DUKE POWER COMPANY

October 7, 1983

Re: RII:WCL
50-413/83-22
50-414/83-19

Duke Power Company
Catawba Nuclear Station

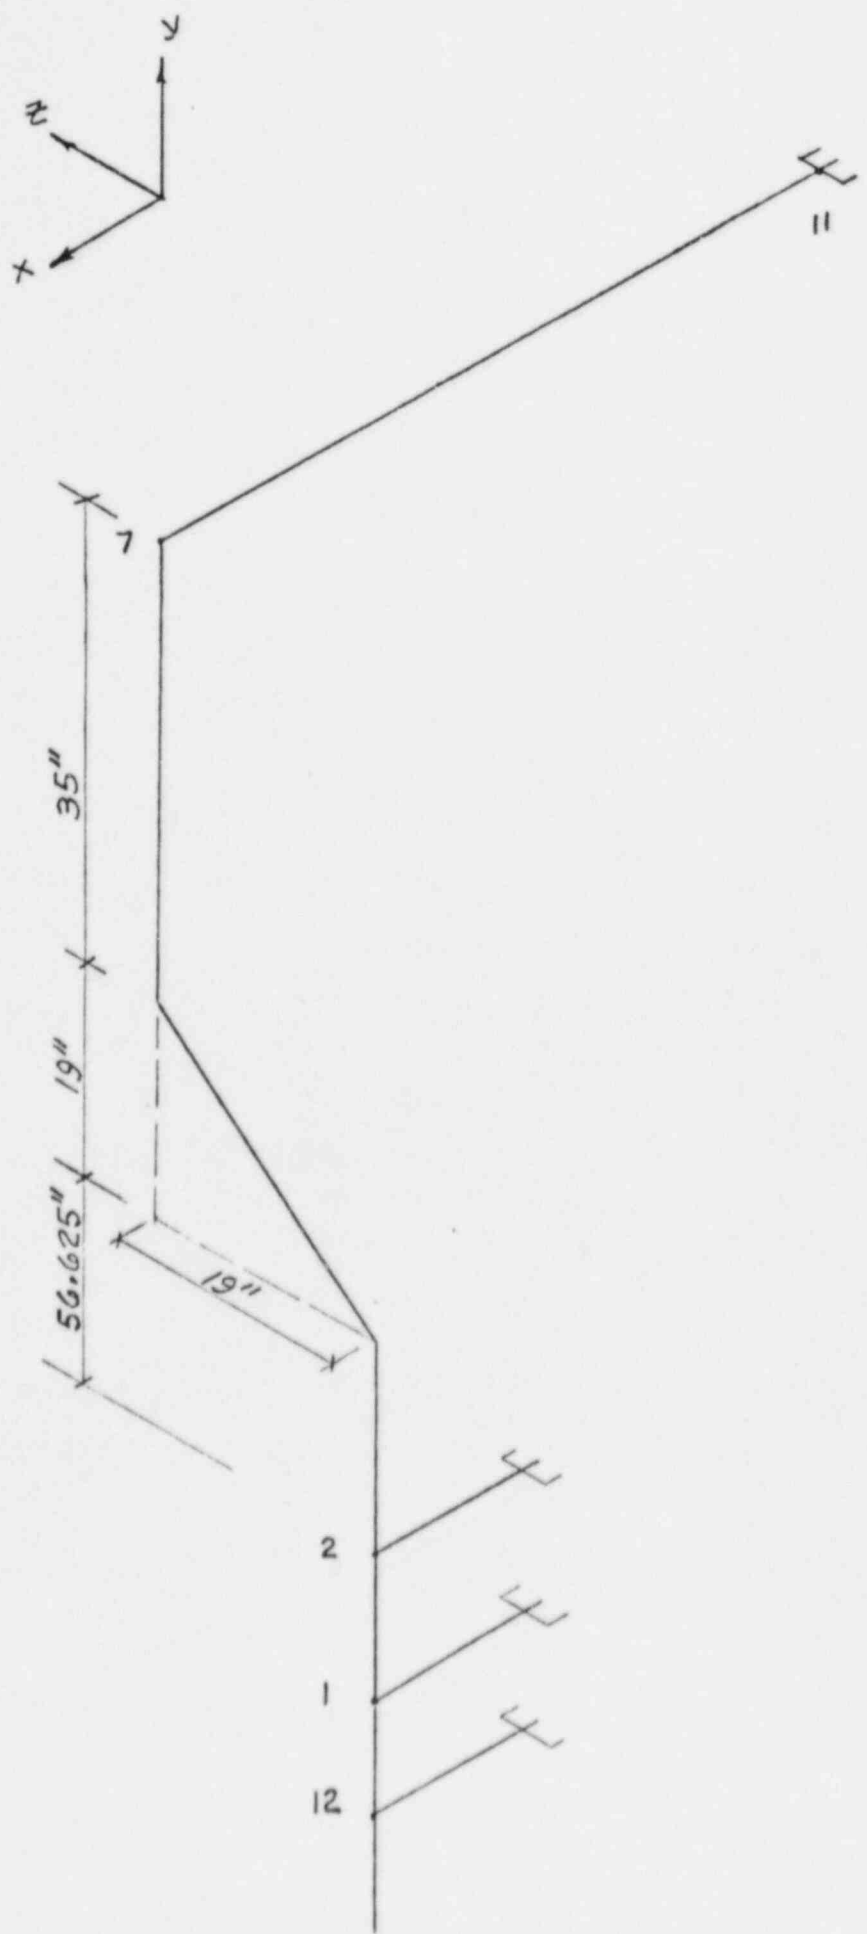
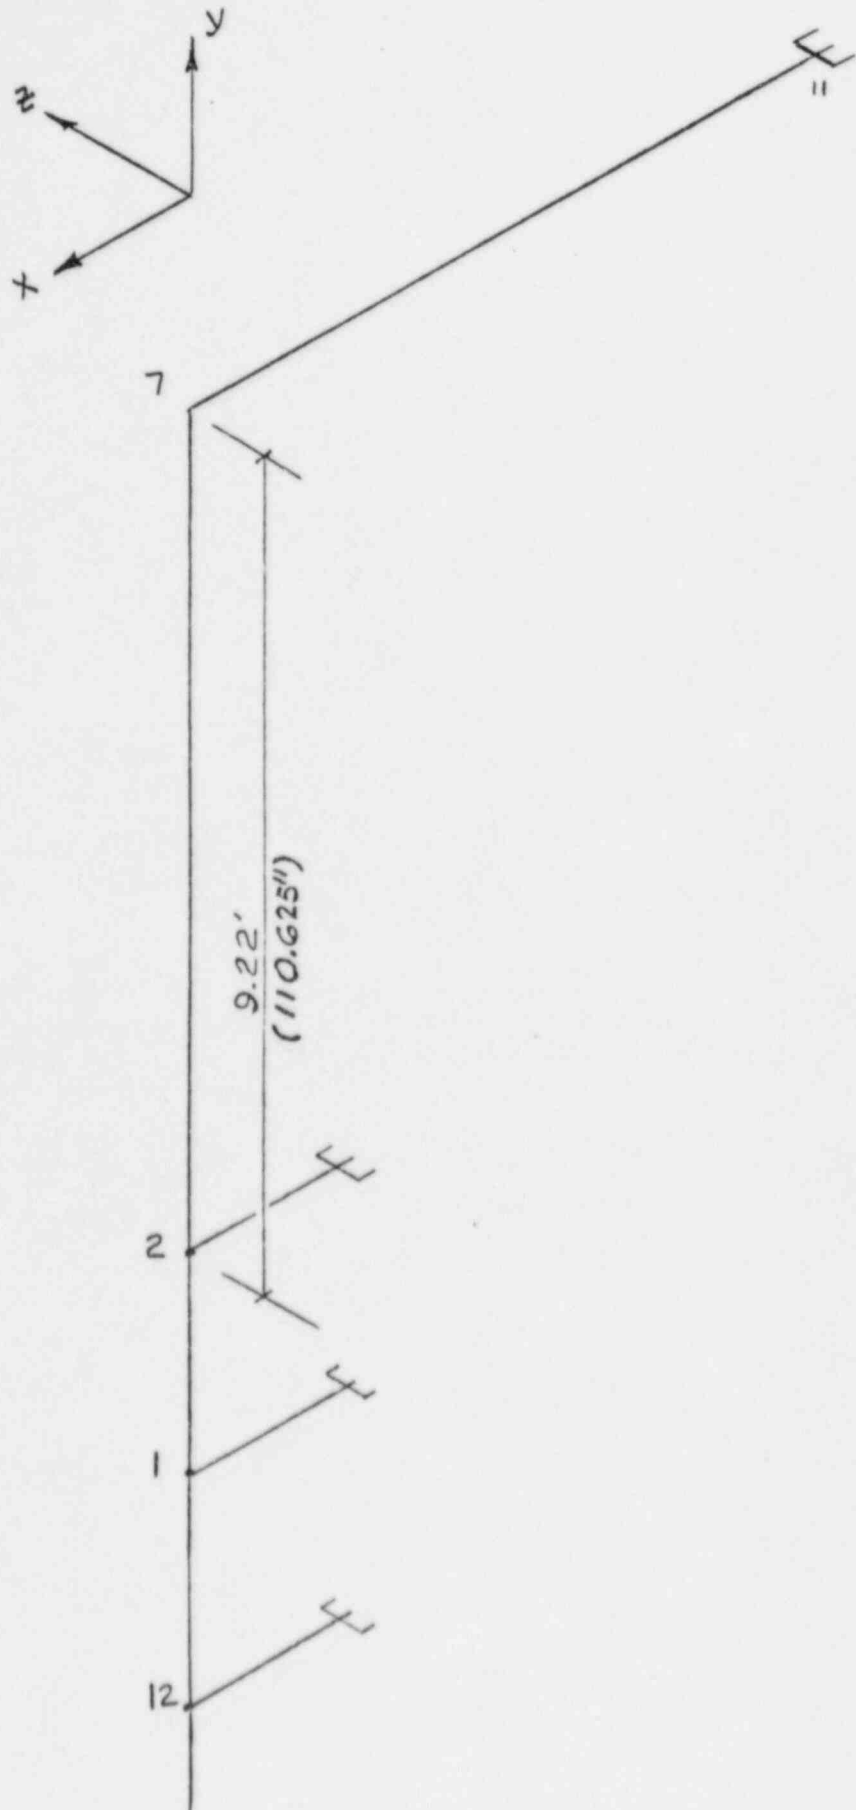
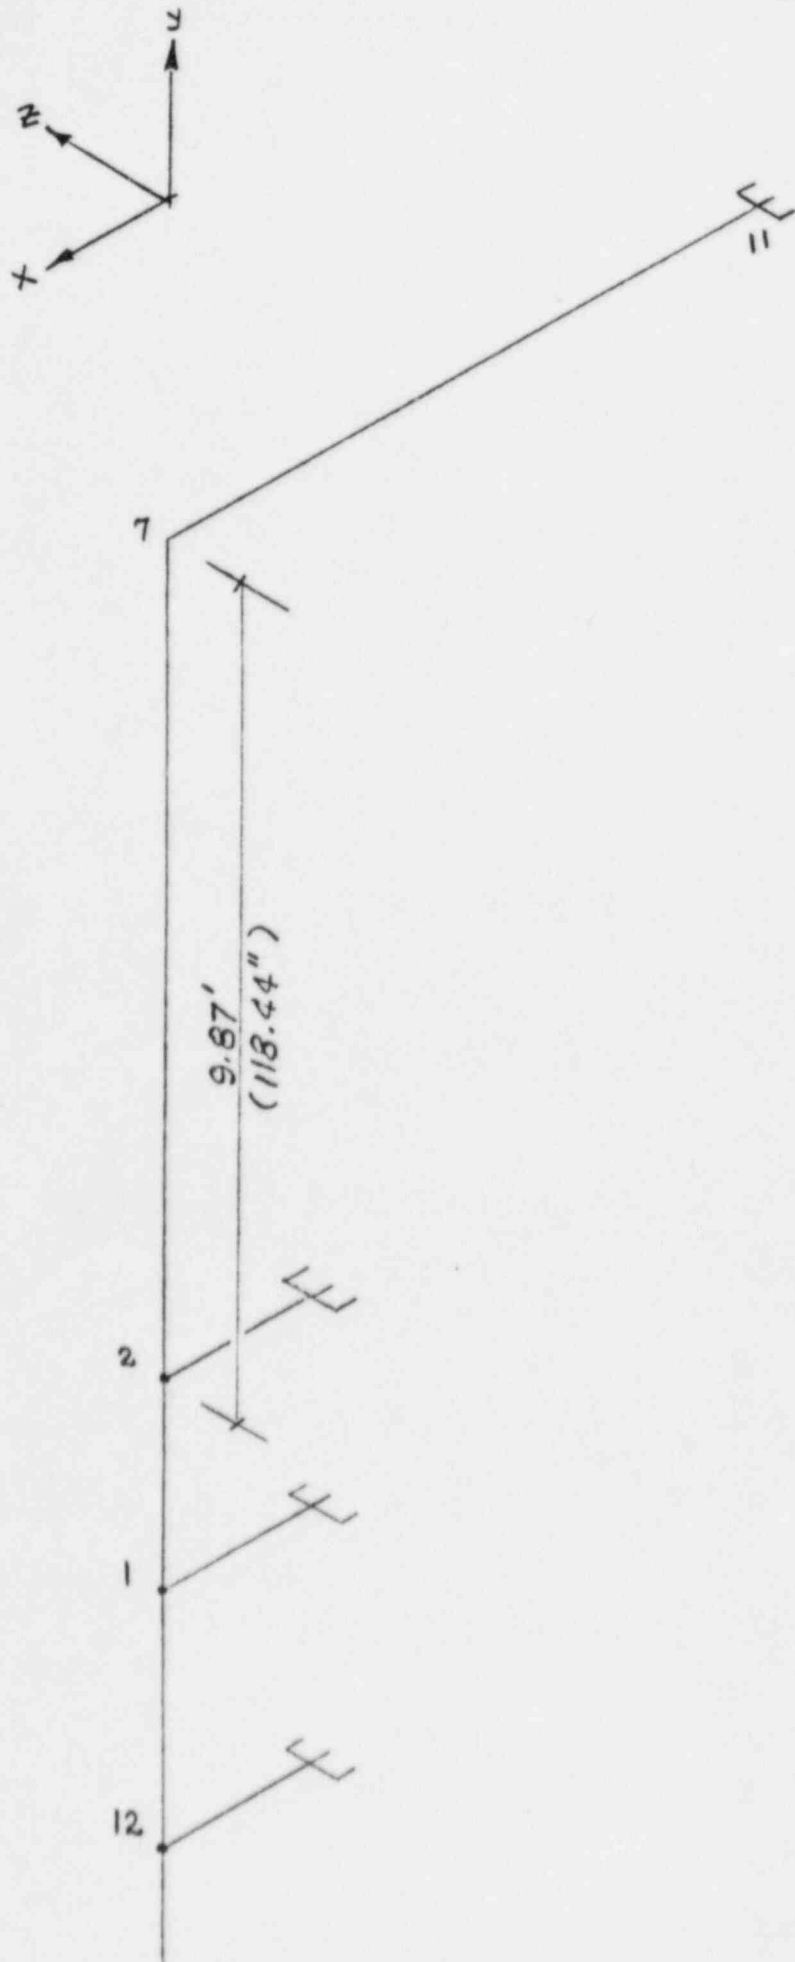
3. In problem CN-1492-NB-179A the thermal growth from the rigorous anchor on isometric CN-1492-NB-152A is absorbed into a piping run that contains a 45° offset that is perpendicular to the thermal displacements. The criteria presents idealized piping configurations and it is the task of the designer to relate the actual configurations to the cases presented in the criteria. It has been the general practice of the Catawba Alternate Analysis Subgroups to use the summation of lengths of each section to determine the equivalent bending length whenever a bending leg contains an offset of 45° or less, perpendicular to the thermal displacements. In order to verify the validity of this practice we have run a computer analysis of the segment of piping questioned using three different configurations. (See attached sketches). The thermal deflection of 0.3151 was input and the resulting force at the anchor was compared among the three cases and with the results of the force calculated by the designer in the calculation. The results are shown below:

Case 1: Computer run of the actual piping configuration including the 45° offset.	<u>Force at Anchor</u> 61.76 lbs.
Case 2: Computer run of the piping configuration with a straight run using the projected length of the offset (Method suggested by the inspector.	67.00 lbs.

| Case 3: Computer run of the piping configuration with a straight run using the summation of each piping segment lengths. (Method used in the calculation) | 57.24 lb. |
| Case 4: The use of the summation of each piping segment length for an equivalent length to be used in the Alternate Analysis Criteria. (Taken directly from calculation) | 143 lb. |

As can be seen from the results, Case 3 gives results closer to the results of Case 1 than does Case 2; and Case 4, which is the past and current practice, gives an extremely conservative approximation of the force as compared to either of the computer analyses.
